क्रमांक: प्रशा-डी-तीन-10307 / 1491
सेवा में,

विषय: Diversion of 33.71 ha (5.69 in Jind Division 17.79 ha. in Hisar, Division 10.23 Ha. in Fatehabad Division) of forest Land in favour of Executive Engineer, Adampur Water Services Division, Hisar for Construction of Carrier Channel for Nuclear Power Plant at Village- Gorakhpur, Tehsil & Distt-Fatehabad on old abandoned Sirsa Branch from RD 388500 to 424780 falling, under Forest Division and Disitrtict Jind, Hisar and Fatehabad, Haryana.

Online Proposal No. FP/HR/CANAL/152229/2022

152229.jpg
278K

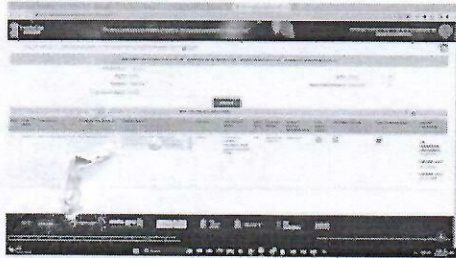
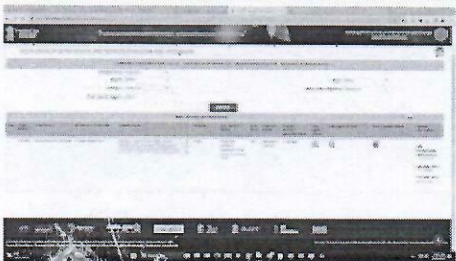
**Please check KML .
URGENT**

CA Site
Hisar Division:

- Revise CA Site of DGPS and KML is correct.
- Toposheet of CA site is marked

- Analysis of additional 3 CA site (Rattakhera Distry RD 0 to 24 R/side, Rattakhera Disry RD 71 to 82 L/side & Fatehabad Branch abandoned RD 204 to 215 R/side), Fatehabad Branch abandoned RD 204 to 215 R/side site has insufficient space for 1000 plantation (Density more than 70 percent).
- Add another CA site for 1000 plantations.(DGPS and KML)
- Toposheet of CA site is marked
